Addendum #2

Project: 2024 – Fishers Elementary School Addition & Renovations

ADDENDUM NO: 2

PROJECT: 2024 – Fishers Elementary School Addition and Renovations

A801D PROJECT NUMBER

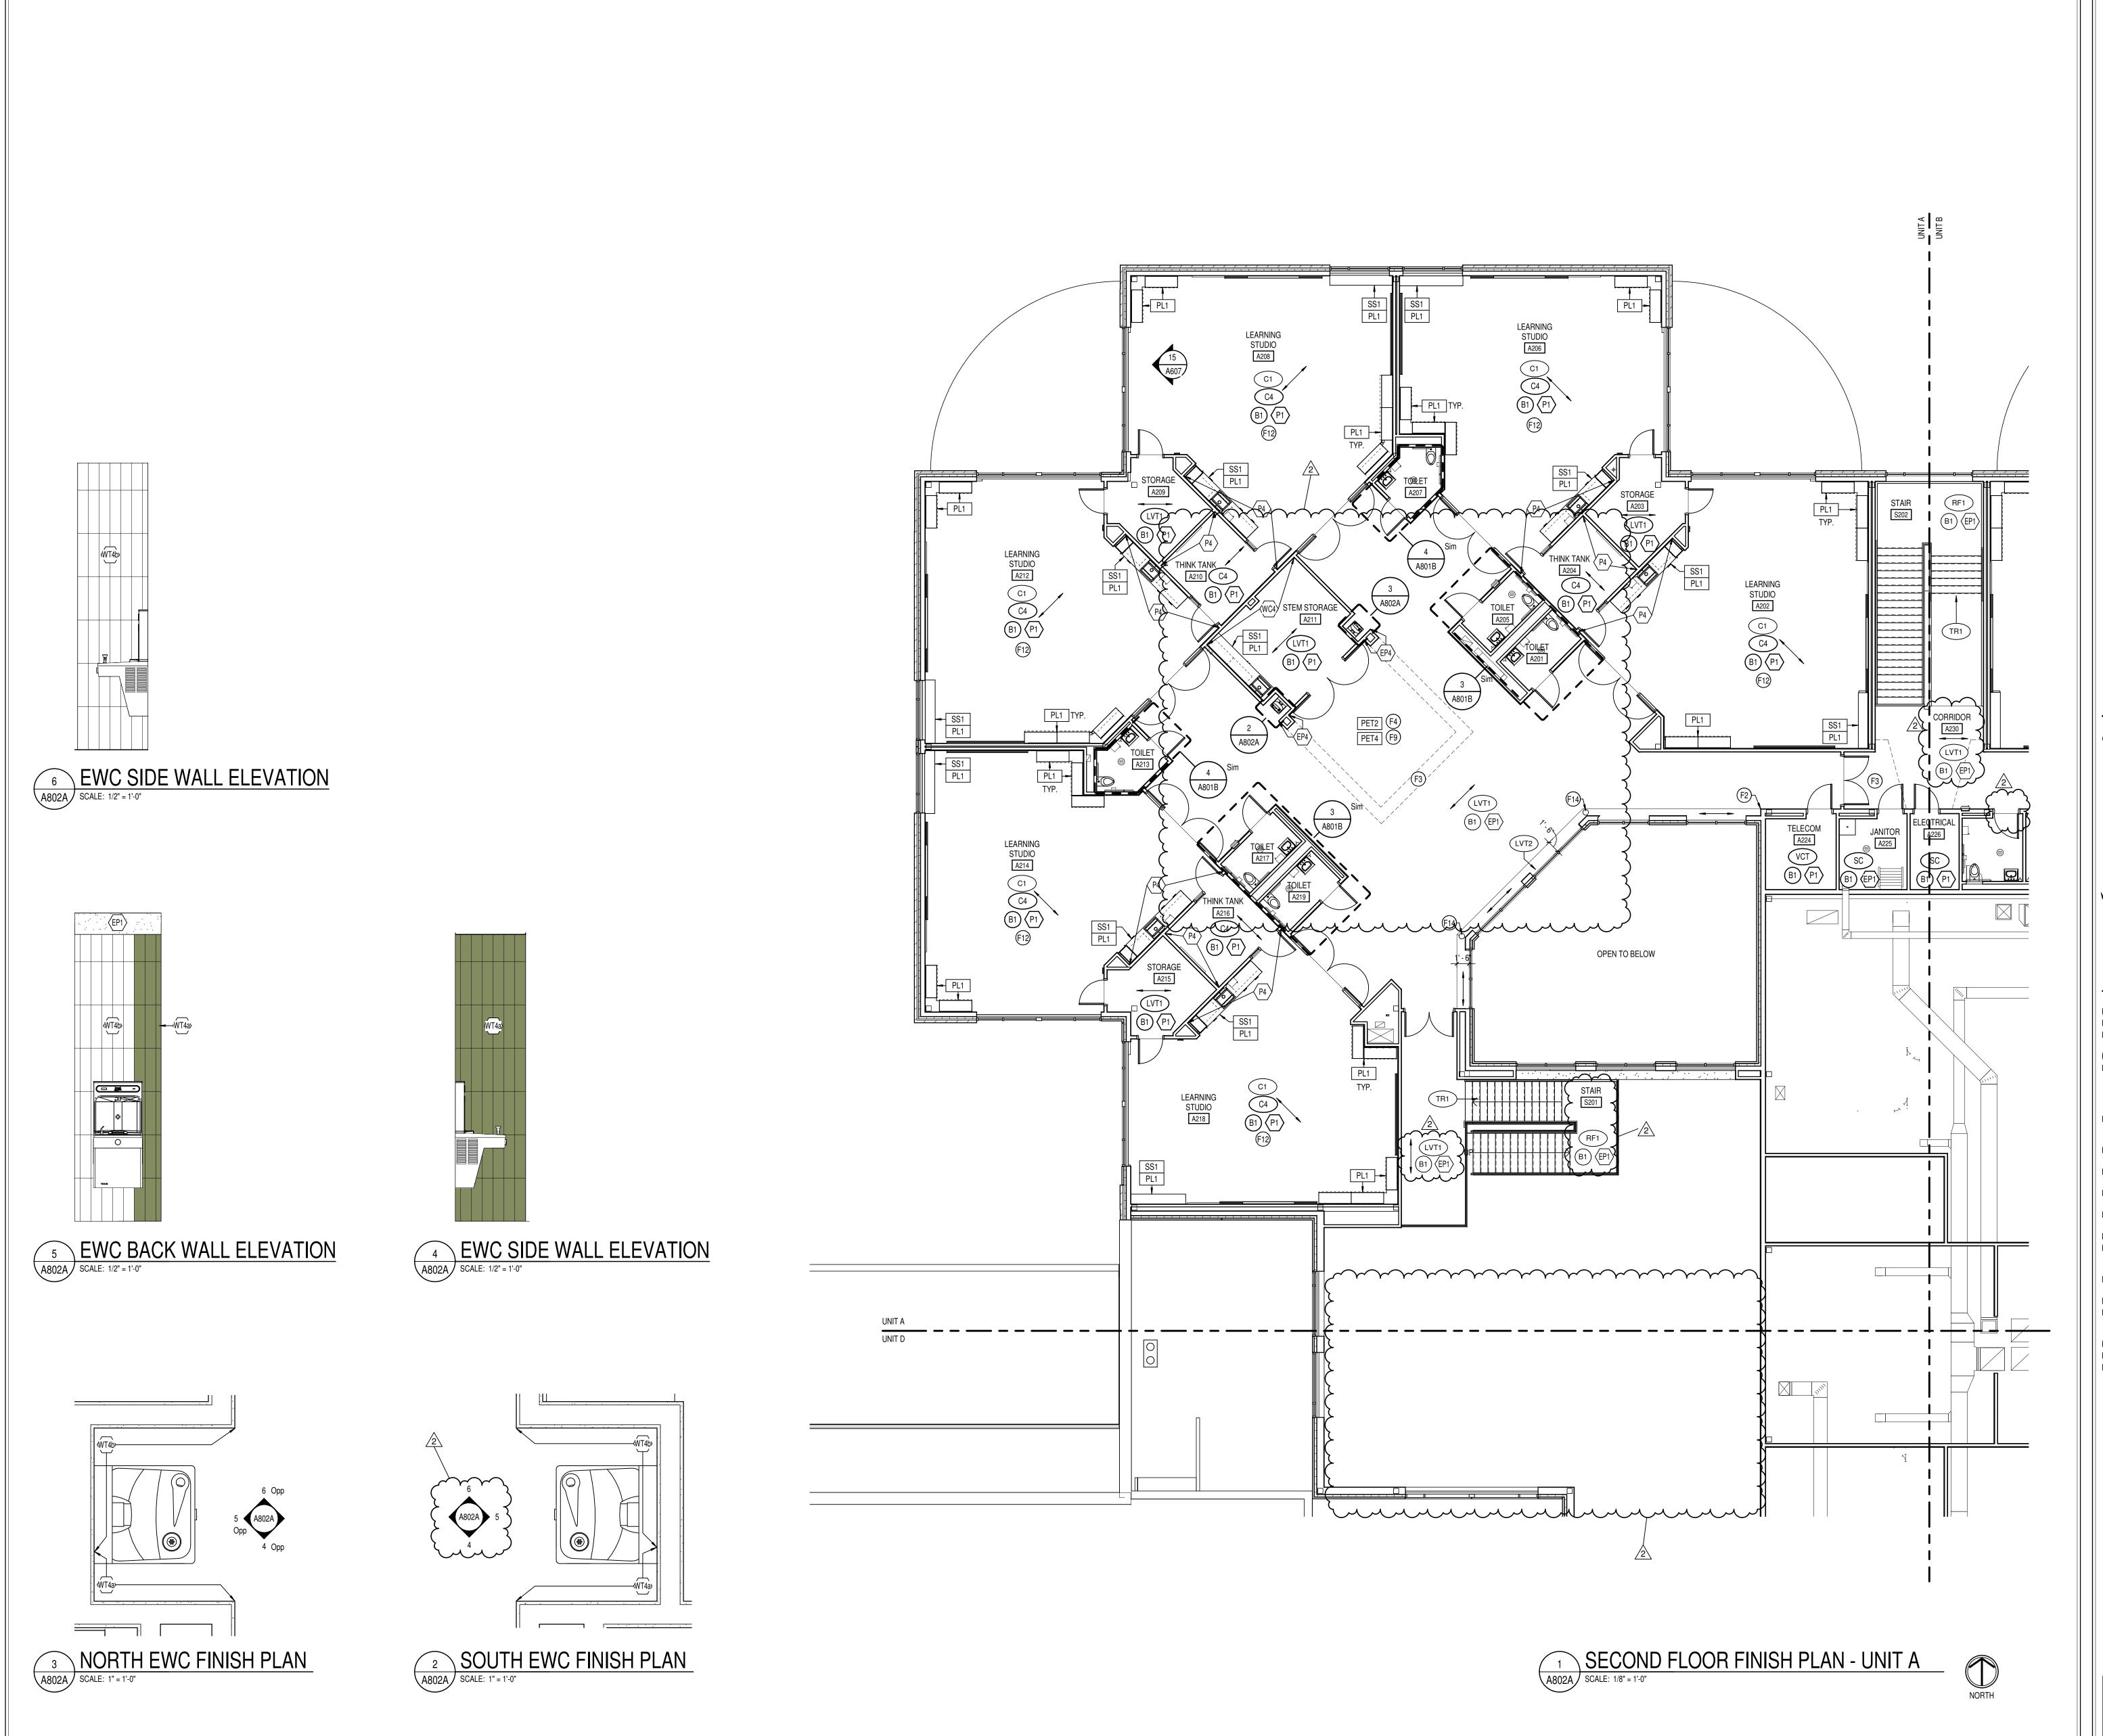
- A. Removed tags for clarity
- B. Revised TB base tags to TB1

#### C. Revised RB1 to TB1 in CORRIDOR D100

DRAWING NUMBER
A802A

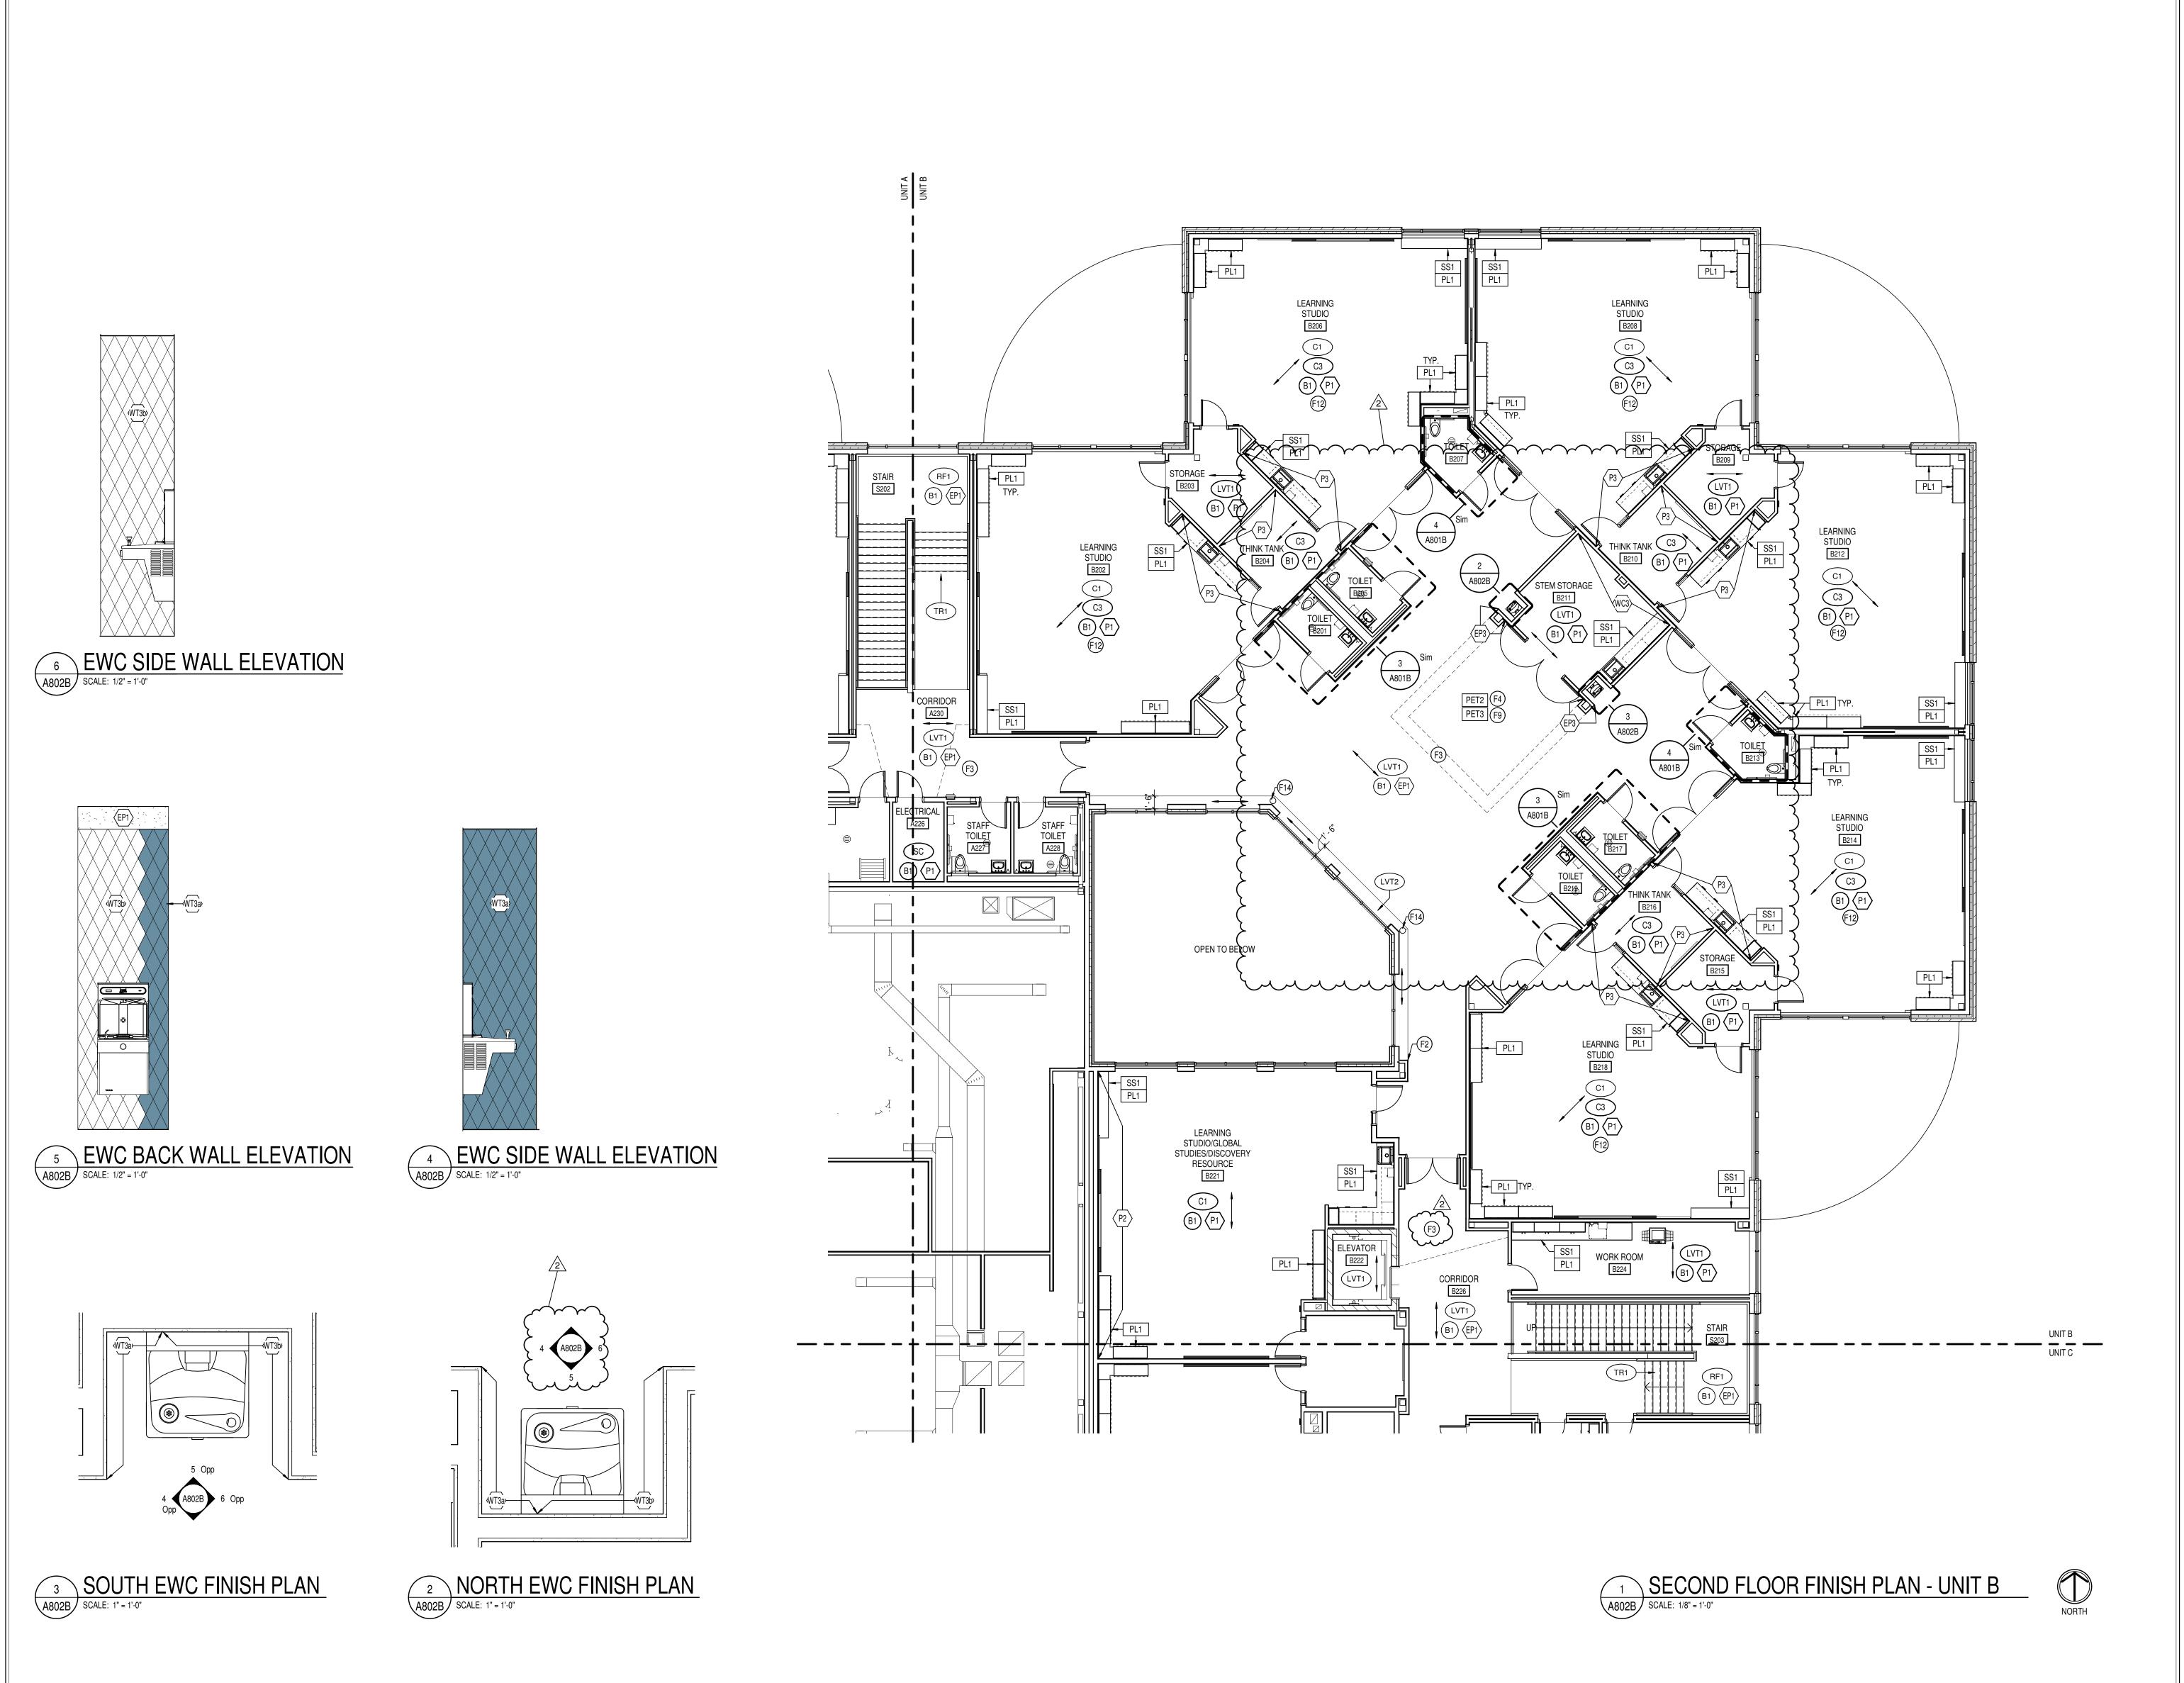
- A. Removed ceiling mounted acoustic flap wings for clarification
- B. Shifted callout tags, room tags, and finish tags for clarity
- C. Added elevation tag to 2/A802A
- D. Added room tag for STAIR S201
- E. Added finish tags and directional arrow near STAIR S201

A802B

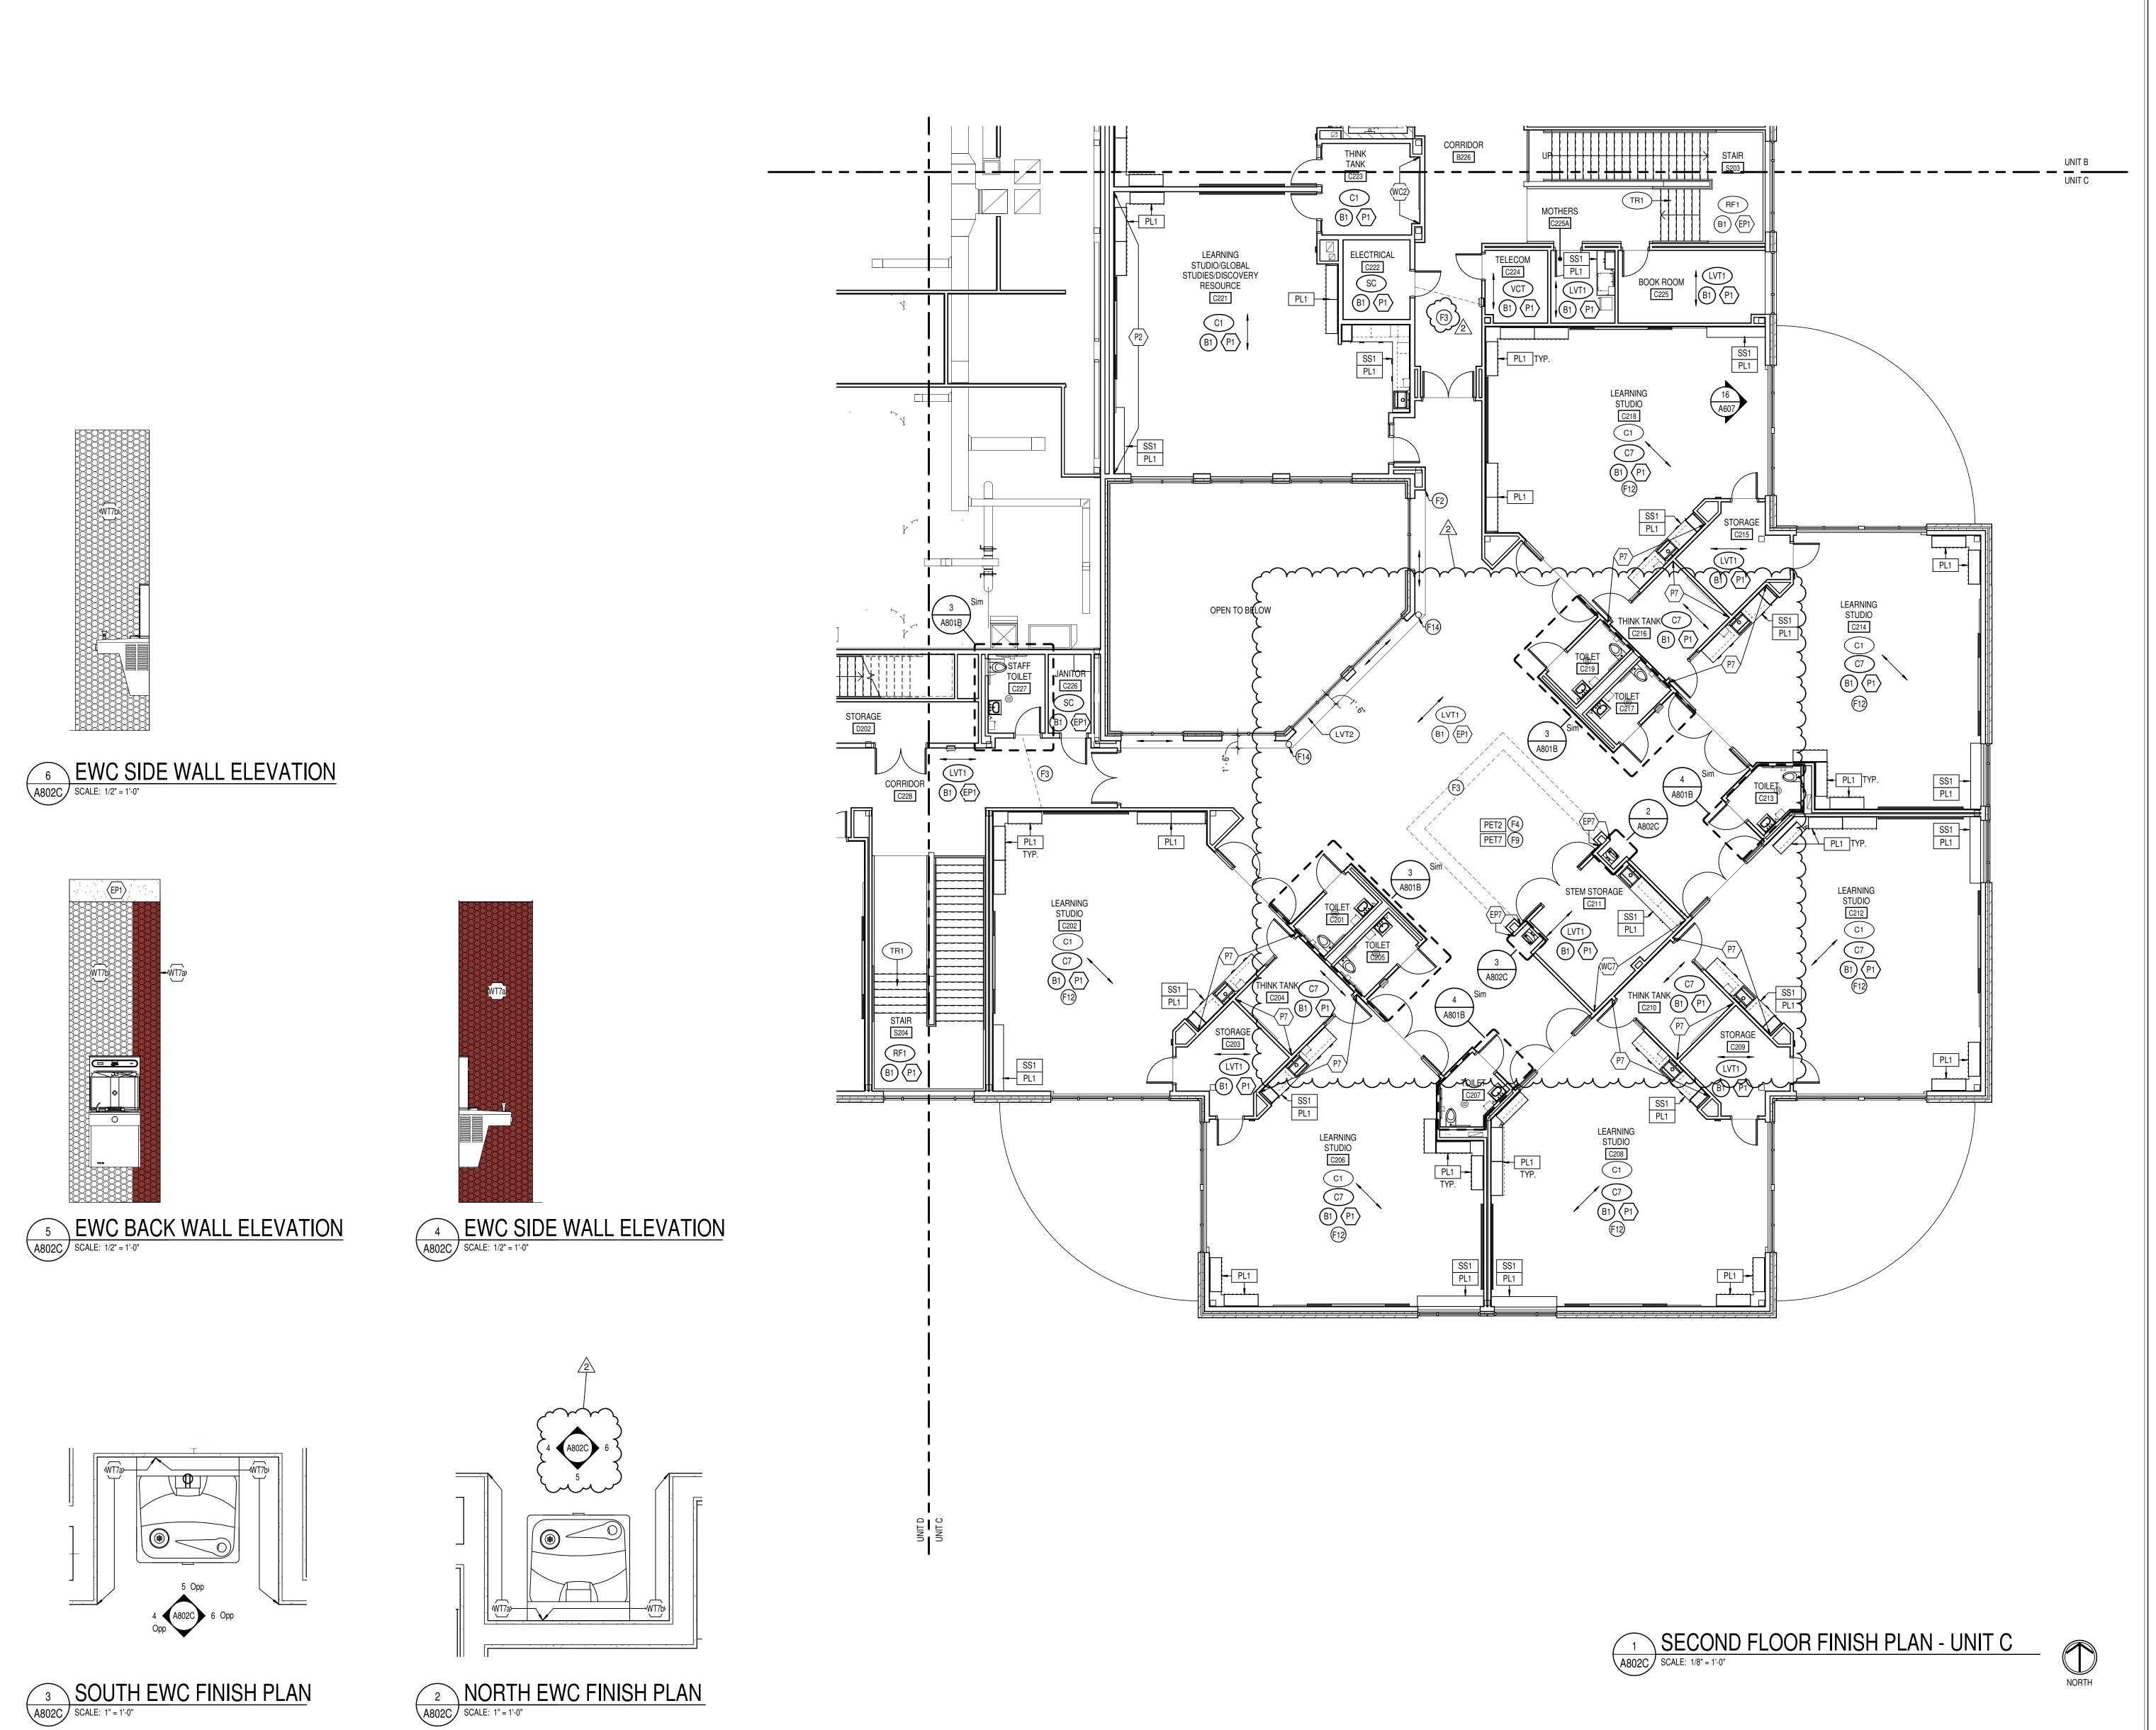
- A. Shifted callout tags for clarity
- B. Added elevation tag to 2/A802B
- C. Added F3 finish tag to CORRIDOR B226
